Magnet Offsets in the Hall Model

Discrepancy between location of TRD and 'As-Built' magnets

Step IV – Actual Hall Model

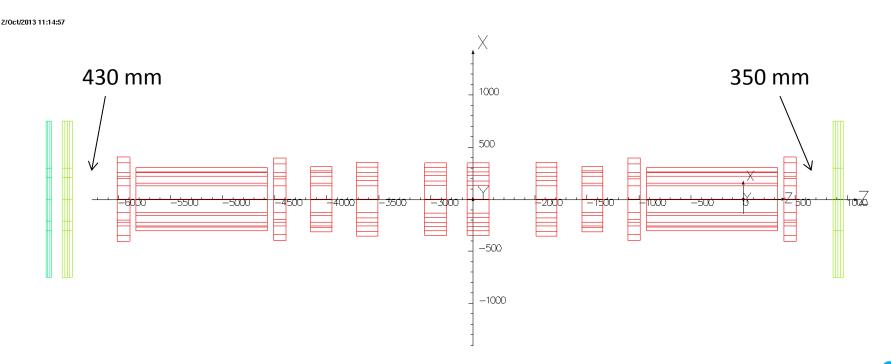
Coil Centre = -2750 mm Centre of VP = -2790 mm

The position of the VP's assumes a gap to the coils of 390mm but the coils as implemented in the model (TRD) are shifted 40mm DS wrt this. I speculate that this has occurred because the US SS was pinned to its fixed location pre RFCC extensions.

For symmetry (which is what you would obtain with as-built magnets) all the step IV TRD coils need moving East by 40mm giving a 390mm gap at each end of the channel. This gives the correct nominal gap distance as there are no RFCC extensions in the step IV cooling channel.

Step V – Actual Hall Model

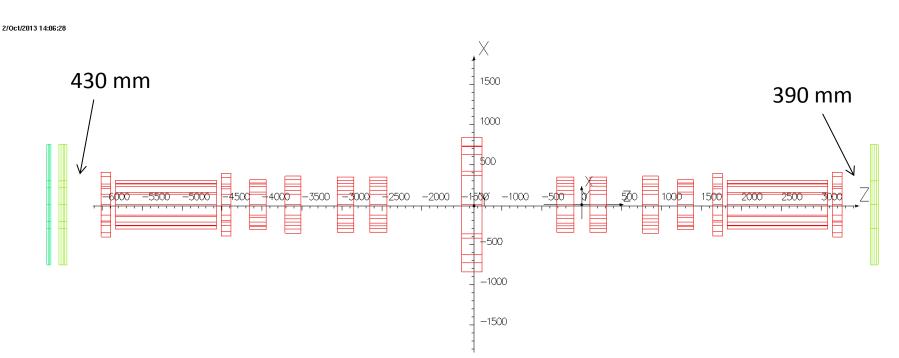
Coil Centre = -1375 mm Centre of VP = -1395 mm

The position of the VP assumes a gap of 390mm but the coils are 40mm short of this at opera the US end because the TRD coils don't include the RFCC extensions. (This is 2x20mm per Coupling coil)

For symmetry all the TRD coils need moving East by 20mm. This will give a gap of 410mm at each end of the channel.
